Bid Addendum No. 2 for:

MASON TRANSIT AUTHORITY – LOG YARD ROAD AND SR 3 ROUNDABOUT PROJECT

MASON TRANSIT AUTHORITY
 BELFAIR
 PARK AND RIDE DEVELOPMENT

GRADING AND DRAINAGE PLAN

DRAWING No.: SD-1
 SHEET No.: 6 of 11

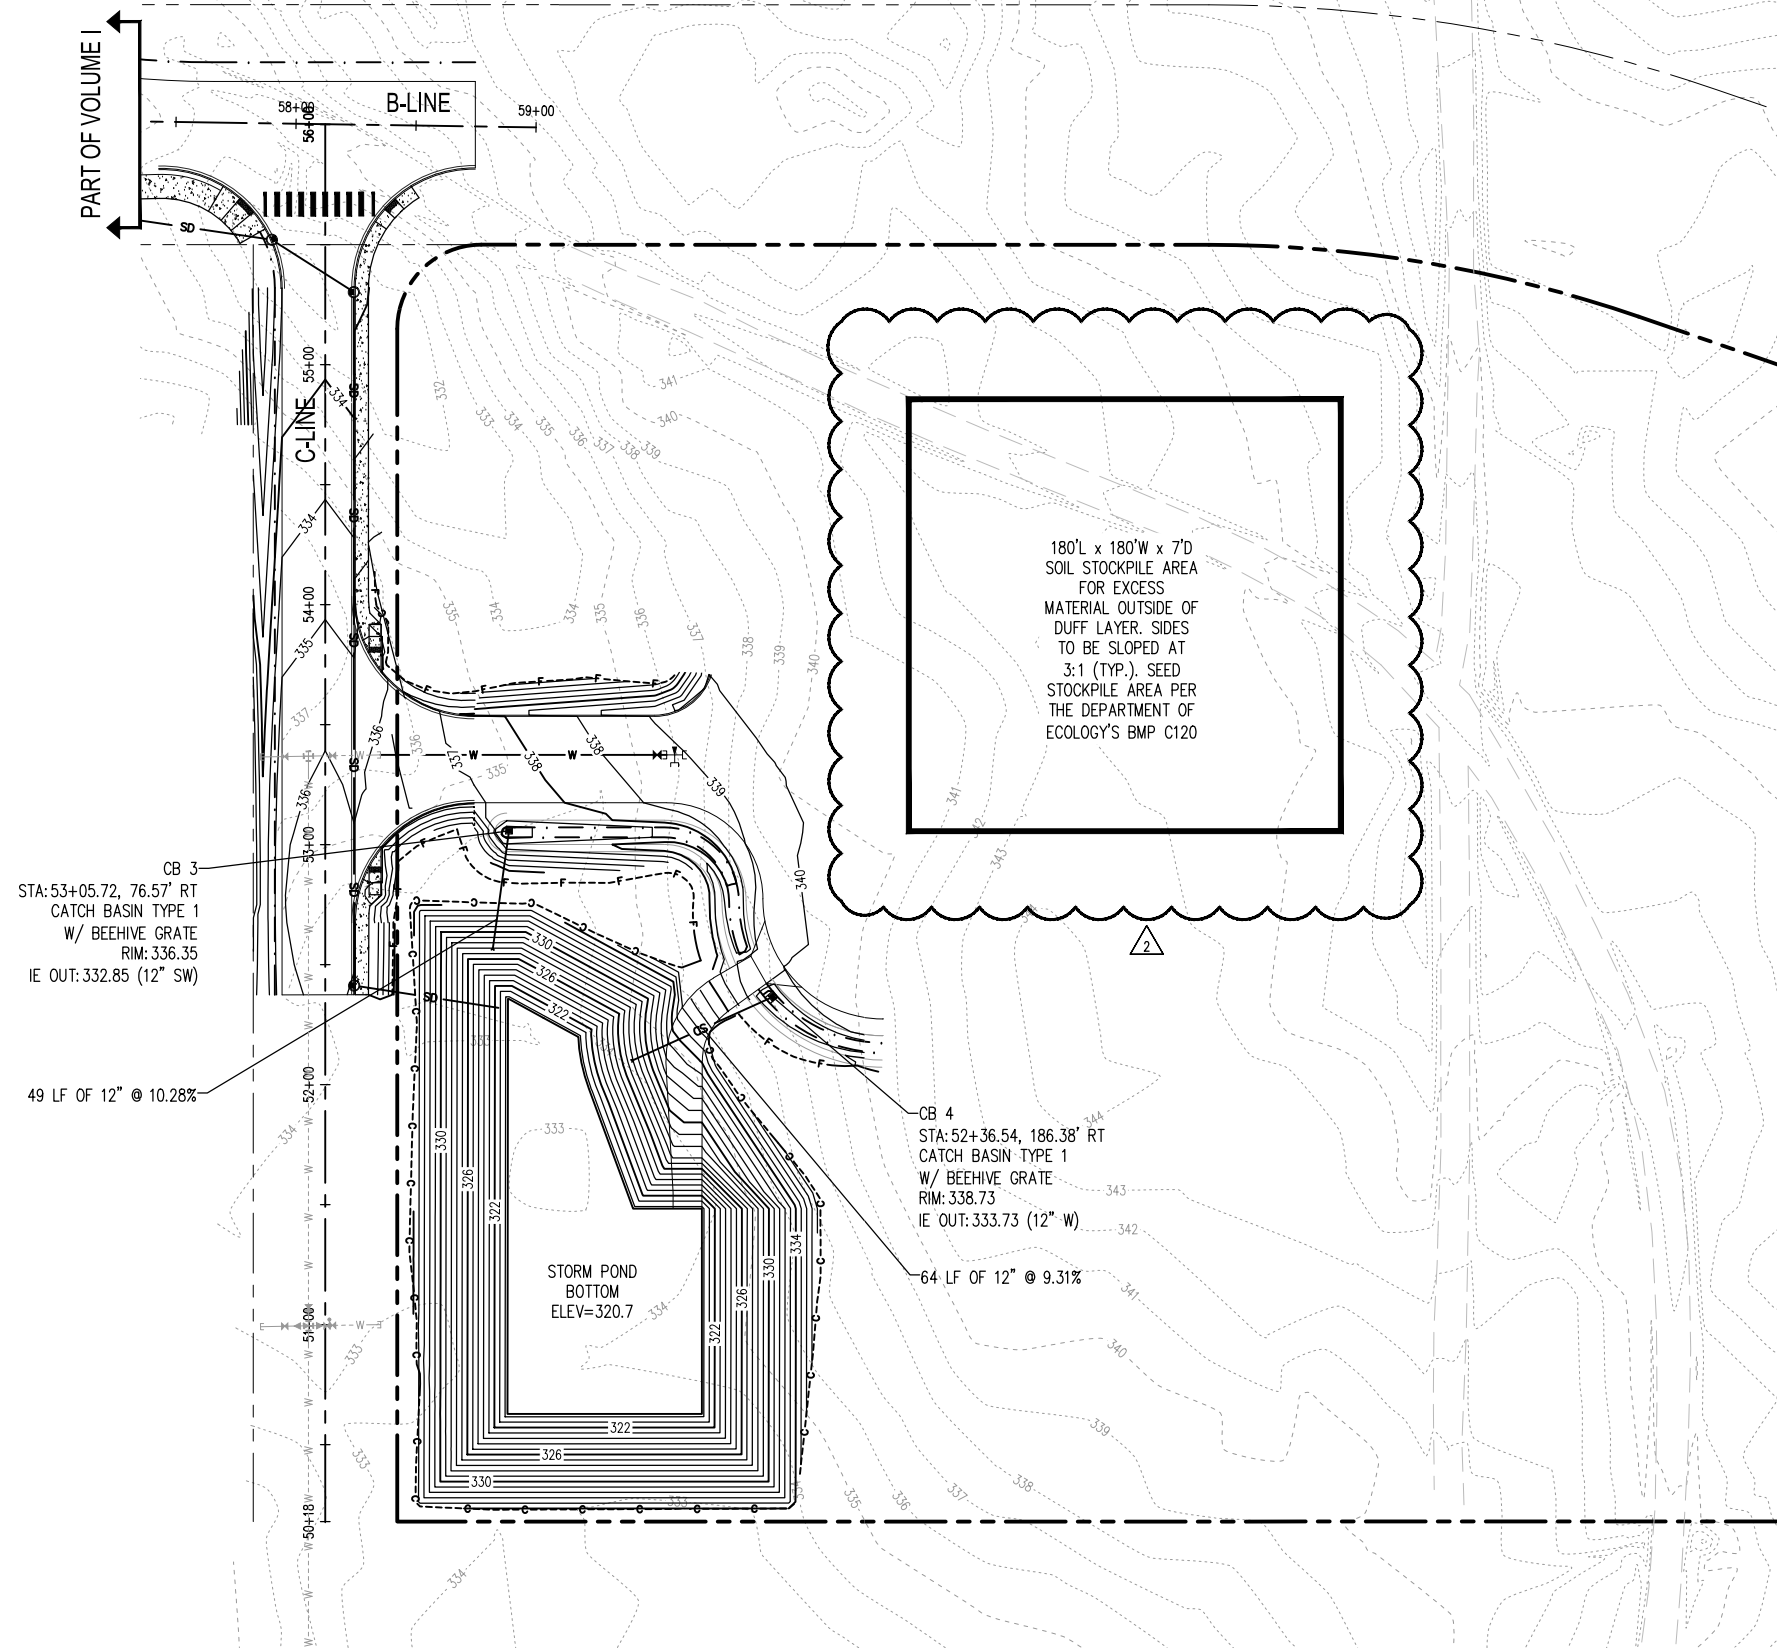
Sheet SD-1:

- A stockpile area has been added to the sheet.
